12-GTRBR-06

JC comments (brown) on 2006-03-13

DRI revisions to the test plan, and replies to IMMA and other comments, are in blue. Many of the latter replies are simply questions of clarification, answers to which may assist in refining or clarifying the revised test plan.

Test Plan Motorcycle ABS testing related to Draft GTR

For purposes of the analysis and discussion, it is proposed to record rider rating using the following subjective rating scales:

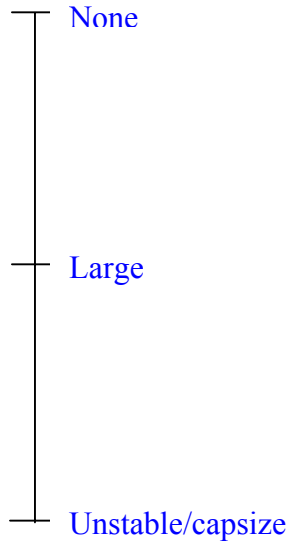
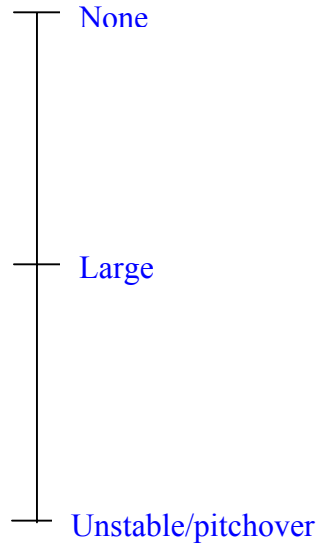
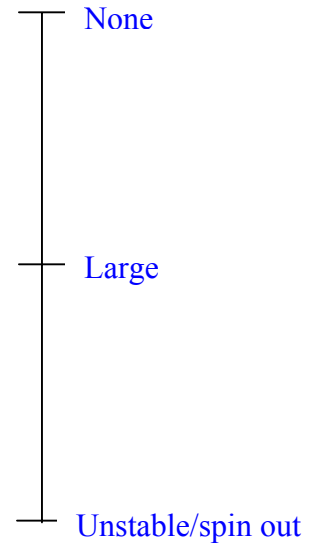
As noted in the last blue paragraph under "Test Procedures," the description under 4.9.1 of "requiring the operator to release the brake" is felt to be overly vague, subjective and not physically possible because, if the front wheel locks on a low μ surface, the motorcycle will capsize long before it is possible for a human operator to sense, and to respond by "releasing" the control.

As an alternative, it is suggested to clarify the text to say:

"Wheel-lock shall be allowed provided that the stability of the vehicle is not affected to the extent that it causes the vehicle to capsize or that it causes a vehicle wheel to pass outside the applicable test lane."
